REVISED - PLATTING BOARD AGENDA **ASSEMBLY CHAMBERS** **350 E DAHLIA AVENUE PALMER**

PLATTING BOARD MEETING **1:00 P.M.** **October 3, 2024**

A. **KATAGNIK RANCH ESTATES PHASE 1:** The request is to bring the approved Katagnik Ranch 2022 back for modification. The petitioner proposes creating six lots and one tract from Lot 1 and Tract A, Katagnik Ranch, Plat 2017-115, to be known as **KATAGNIK RANCH ESTATES PHASE 1**, containing 40.0 acres +/- . The petitioner is dedicating and constructing one interior road. The property is located east of S. Knik-Goose Bay Road, directly west of W. Connor Court, and northwest of Nichols Memorial Park (Tax ID # 7689000L001 & T00A); lying within the NW ¼ Section 35, Township 17 North, Range 02 West, Seward Meridian, Alaska. In the Knik Fairview Community Council and in Assembly District #5. *(Petitioner/Owner: Mike & Terry Dennison, Jimmie Chynoweth & Nicole Baston, Staff: Chris Curlin, Case # 2022-112)*

FIGURE
 2

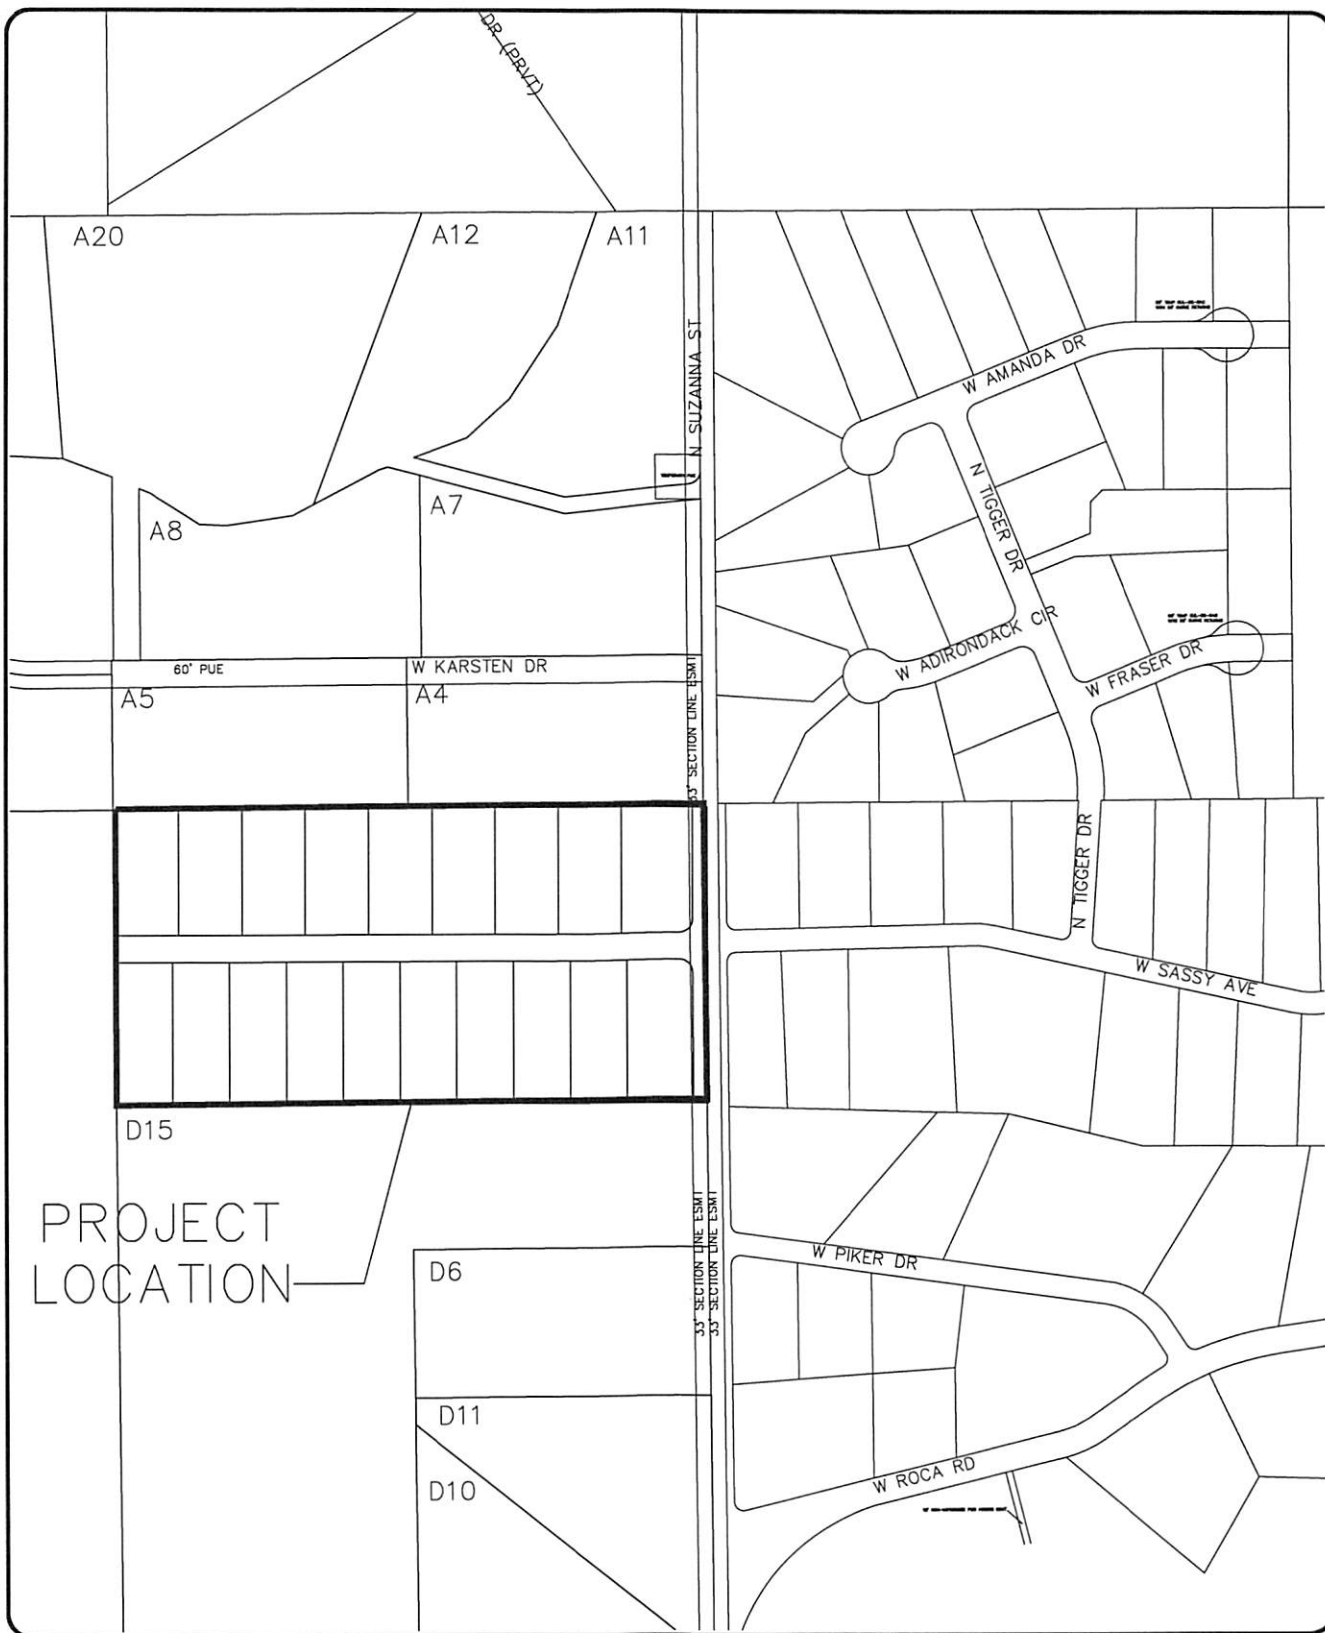
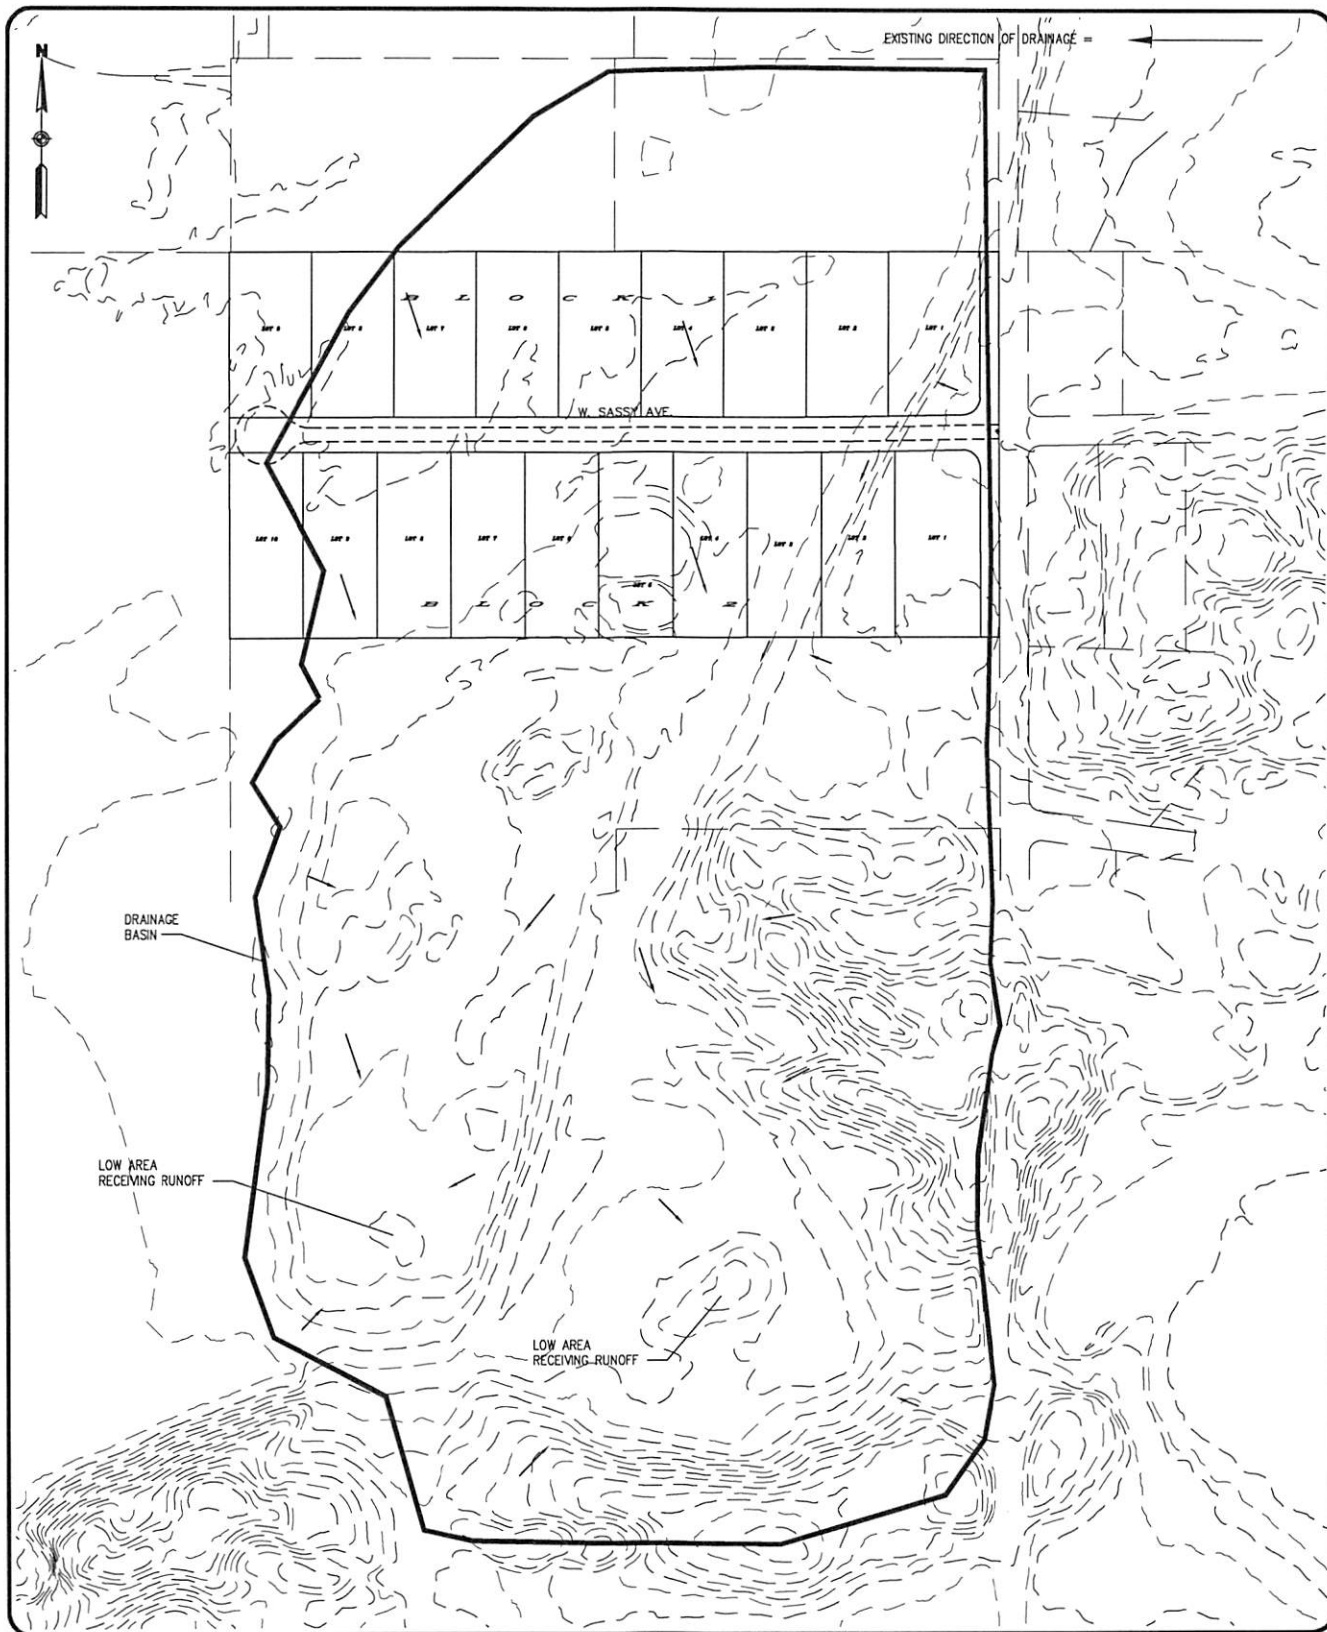
Average Daily Traffic (ADT) count is at Figure 2, **Exhibit B-5**. *Staff notes that this exhibit reflects an updated figure which includes the current design to construct N. Suzanna Street. Calculation clarifications were requested by PD&E in response to a previous version of the ADT (see comments at Exhibit F-6); clarification provided by the engineer is at Exhibit B-13.*

MSB Public Works Department, Division of Pre-Design & Engineering (PD&E) (**Exhibit F**) commented that additional ADT information was needed: Tigger Drive calculations, information on traffic coming from Suzanna Street north of Sassy Avenue, expand the ADT drawing to include routes out to Machen Road and Stanley Road, and include predevelopment ADT estimates to show how the development is affecting the roads. *Staff notes that the petitioner has provided the updates and calculation clarifications requested, found at **Exhibit B-5 and B-13**. After the updated ADT was received, PD&E commented that mitigation for road thresholds was necessary and requested that the petitioner provide their plan for proposed mitigation of the issue. Staff notes that the petitioner updated the road design for external construction to include the construction of alternate subdivision access through N. Suzanna Street and thereby decreased the ADT road thresholds which was acceptable to PD&E.*

FIGURE
3

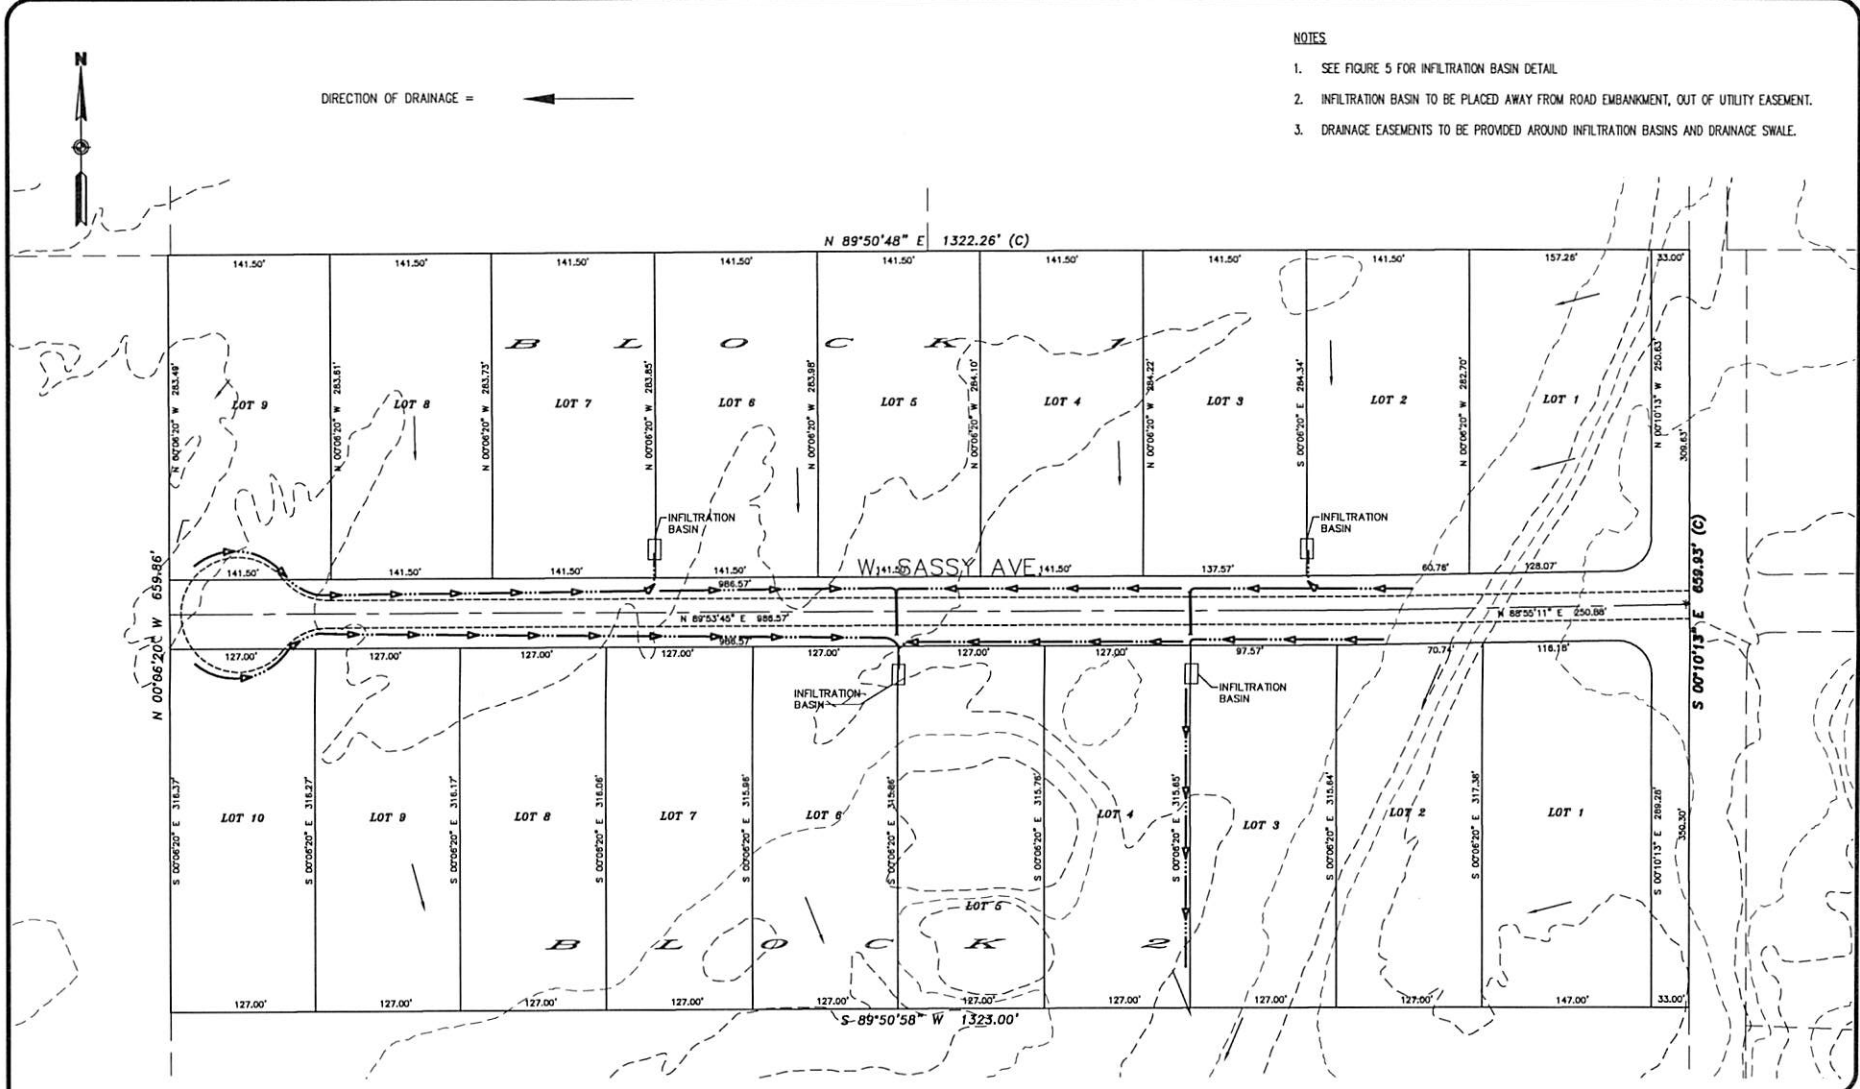
PD&E requested that contours be included on the test hole drawing. *Staff notes that the petitioner has provided the updated test hole drawing, found at Figure 3, **Exhibit B-7**.*

EXHIBIT C - 1

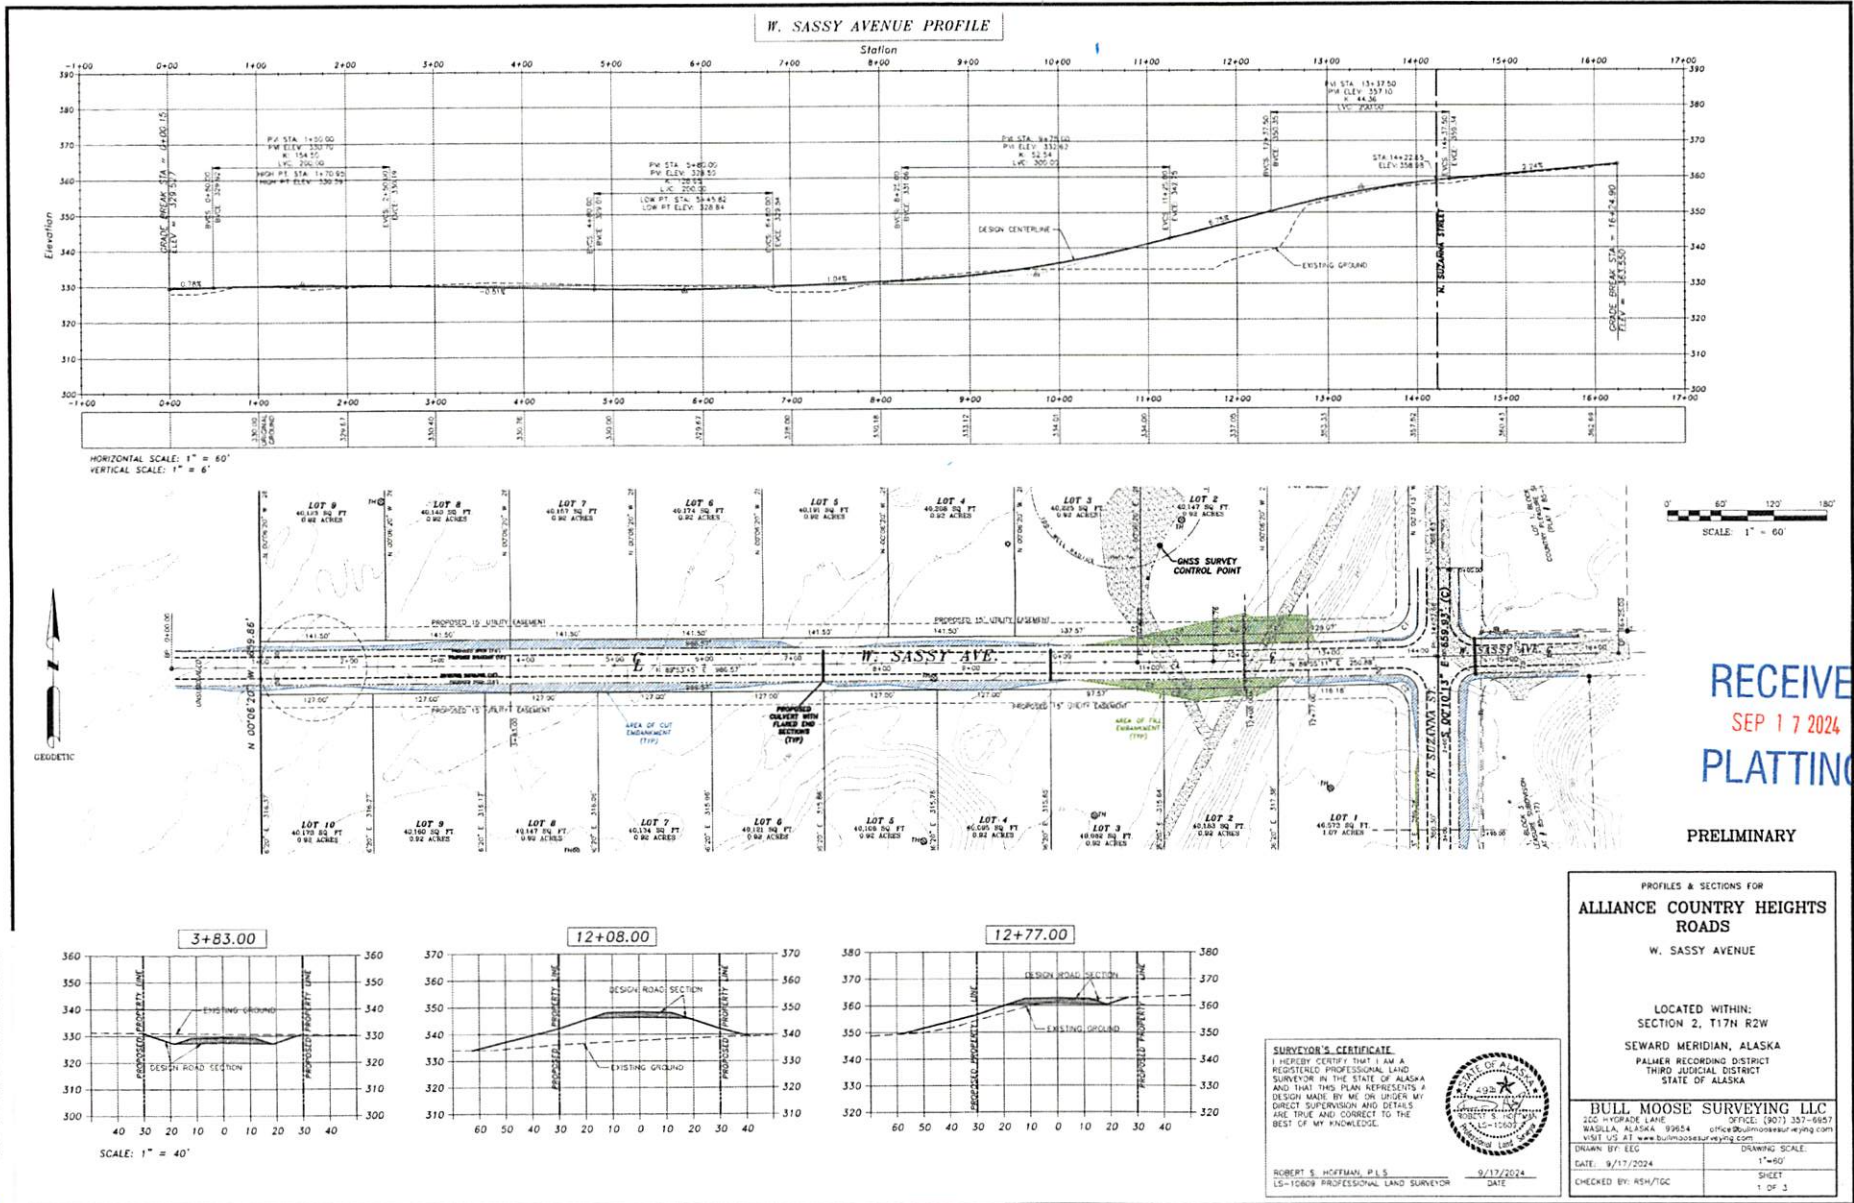
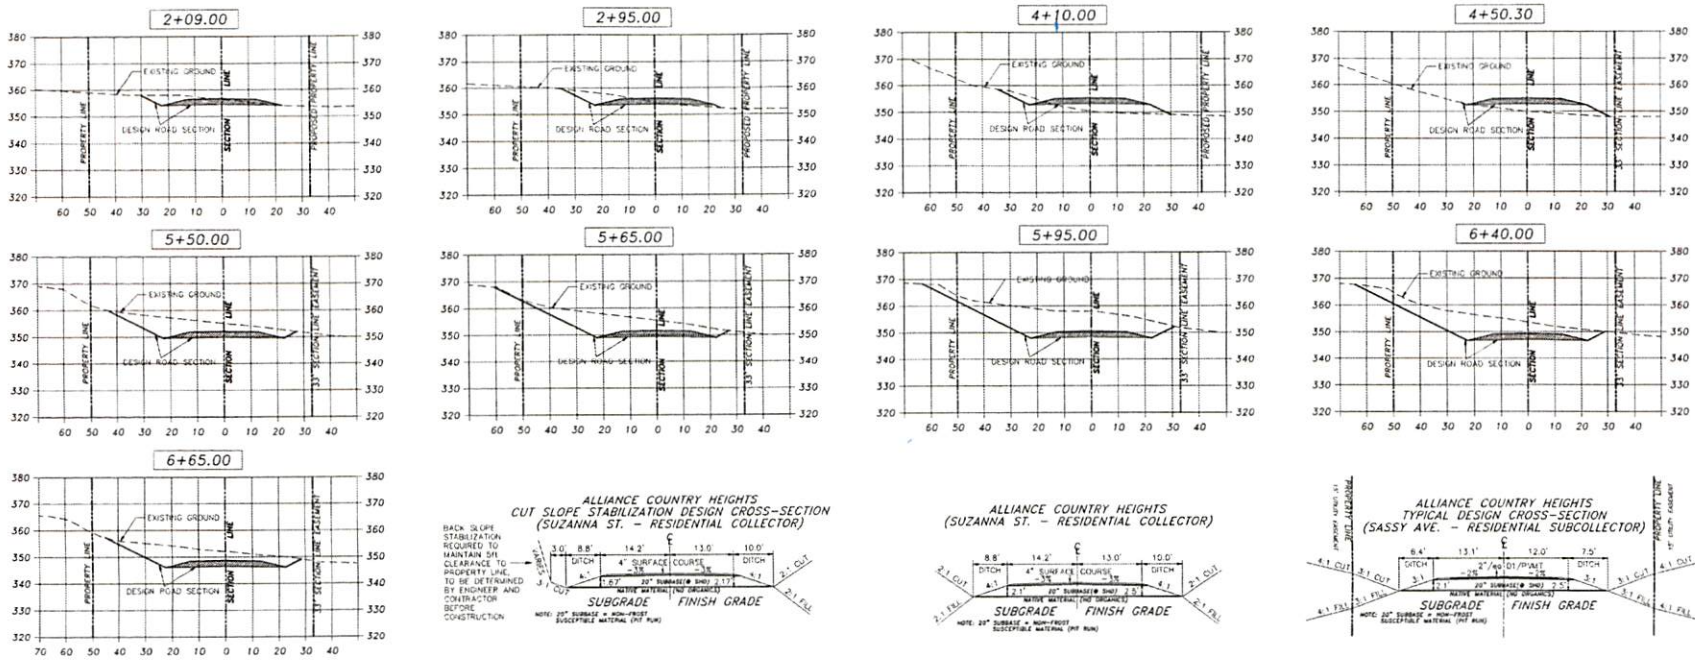
PD&E noted that a cross section at the maximum fill section was required because fills exceed five feet in height measured from the centerline. In response to the updated road design with cross sections included, PD&E noted that per 2022 SCM H02.1(b) "Backslopes or foreslopes which extend into a utility easement should not exceed 4:1. These limits are necessary for construction equipment for utility installation." *Staff notes that the petitioner did provide the updated road design to include cross sections, and the figures found at **Exhibit C** reflect the most updated plans to construct N. Suzanna Street. To the updated road profiles, PD&E commented that additional information to the proposed profile is necessary and that may be coordinated with PD&E prior to the preconstruction conference (see comments at **Exhibit F-1**; see **Recommendation #3a**).*

- **Cross Section:** The provided cross sections show 3:1 slopes in the utility easement. Please redesign with 4:1 slopes within the utility easements per 2022 SCM H02.1(b).

The proposed road will have a grade of over 6%. Road design sheets, including plan and profile, is at **Exhibit C**. All roads will be constructed to a minimum of residential street standards (*see Recommendation #3*). *Staff notes that this exhibit reflects an updated figure which includes the current design to construct N. Suzanna Street. Staff notes that PD&E commented that additional information to the proposed profile is necessary and that may be coordinated with PD&E prior to the preconstruction conference (see comments at Exhibit F-1; see Recommendation #3a).*
